# RESPONSES TO COMMENTS ON THE DRAFT EIR

## 30 Otis Street Project

PLANNING DEPARTMENT  
CASE NO. 2015-010013ENV

DATE: September 13, 2018  
TO: Members of the Planning Commission and Interested Parties  
FROM: Lisa Gibson, Environmental Review Officer  
Re: **Responses to Comments on Draft Environmental Impact Report for the 30 Otis Street Project, Case No. 2015-010013ENV**

FIGURE RTC-1: HUB PROJECT STATUS

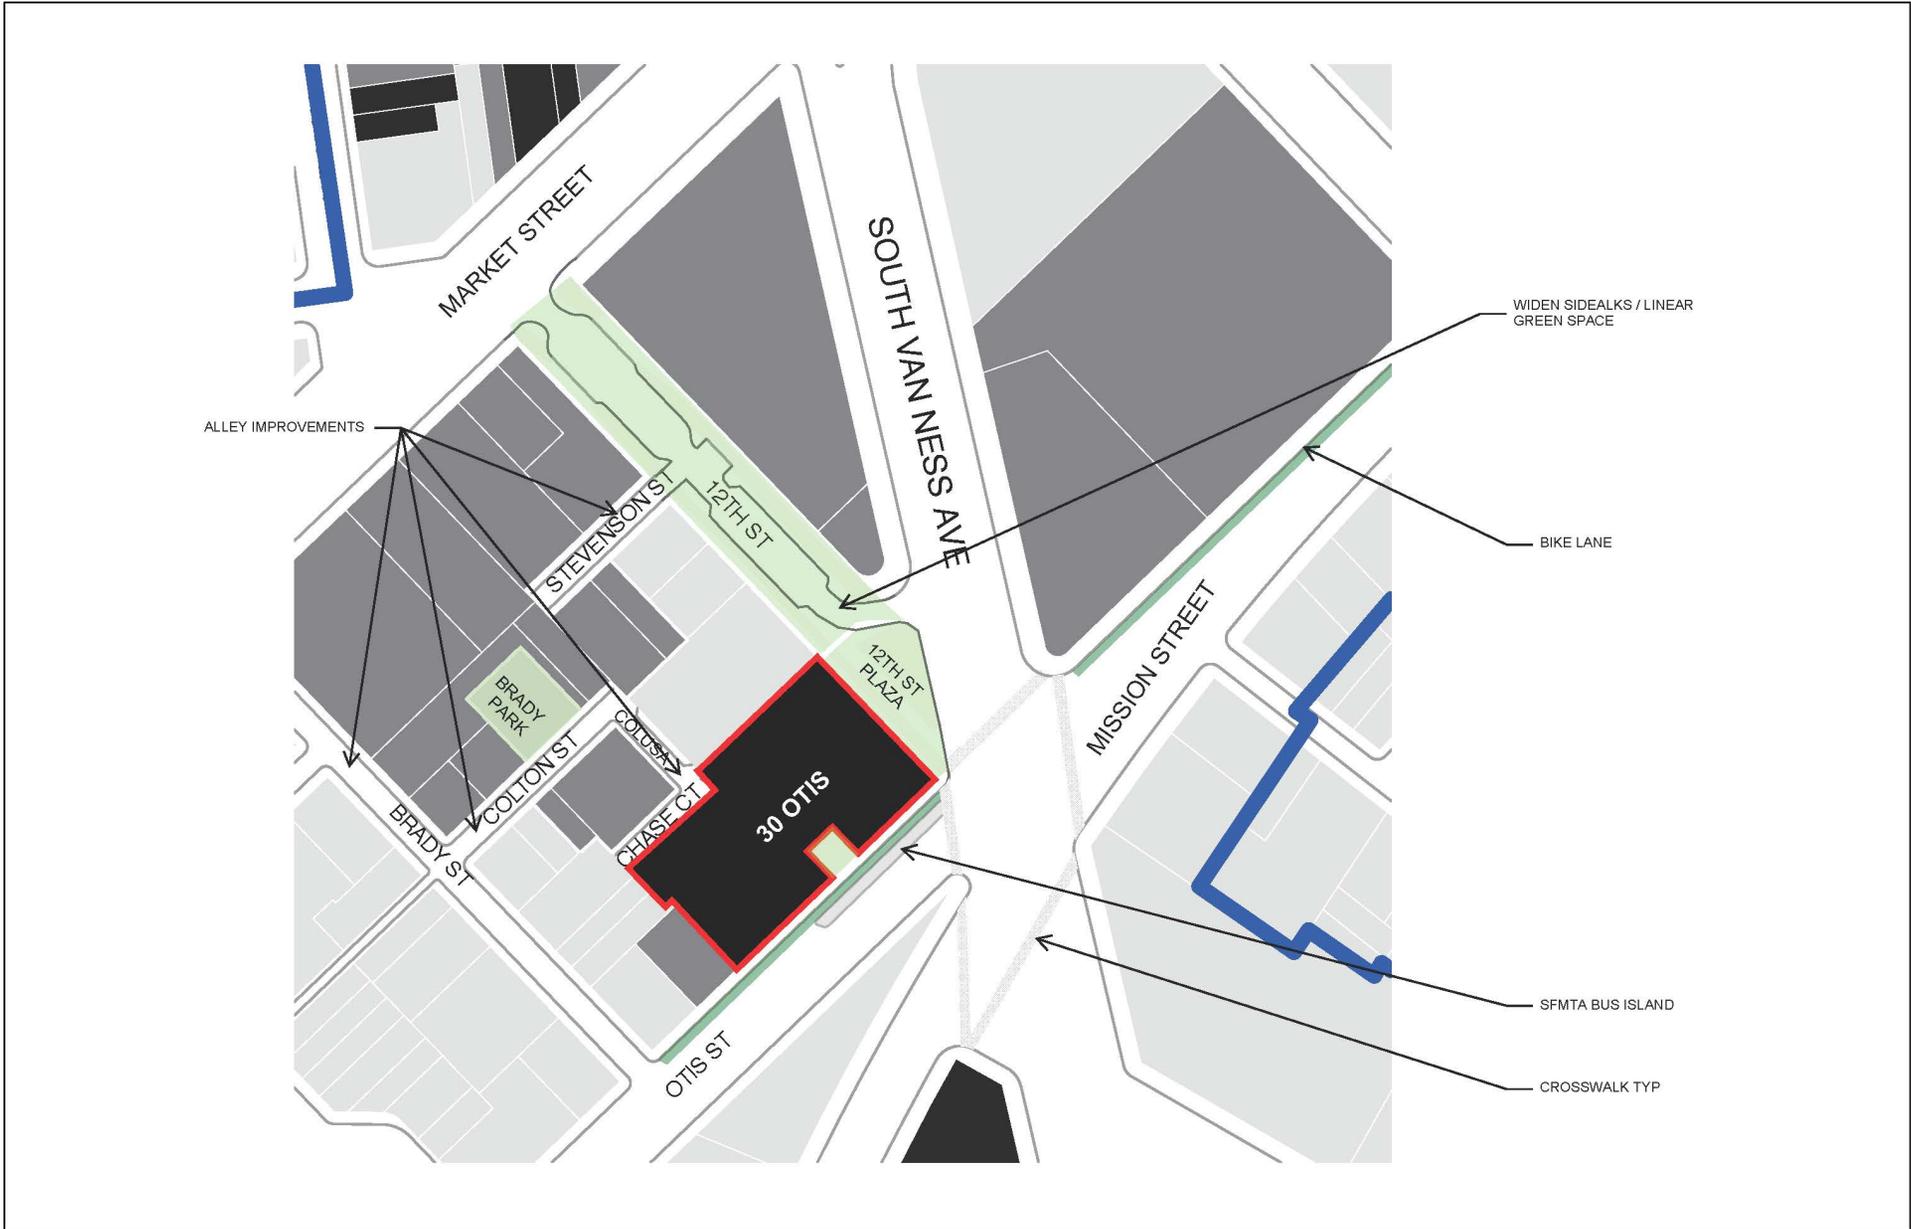
I believe that the EIR as a draft as it's written falls short of giving us a broader overview. One, about the 3D context in which this building will occur. Two, reflecting on the larger principles of the Hub enabled plan pedestrian connections, the open space, light rail etcetera. It has to all work with each other including the simple functioning of the where crosswalks are, where visual relationships and markers are.

And I would suggest that we add a little bit more in that description, so that we when this building -- when the EIR comes forward and ultimately we would be asked to approve the building, the EIR has carefully reflected and described that particular aspect of the project.” (Commissioner Kathrin Moore, San Francisco Planning Commission, Public Hearing Transcript, July 19, 2018, A-CPC1-1, PS-1)

The comments request additional information on the proposed project's context within the Market Street Hub Plan, including status of nearby projects, height and character of

developments, proposed pedestrian connections, open space, and transit improvements. In response to this request, Figure RTC-1, Hub Project Status, below, depicts the cumulative setting along with the Hub Plan boundary, and includes development projects that are consistent with current zoning as well as those that would be reliant upon the proposed Hub Plan rezoning.
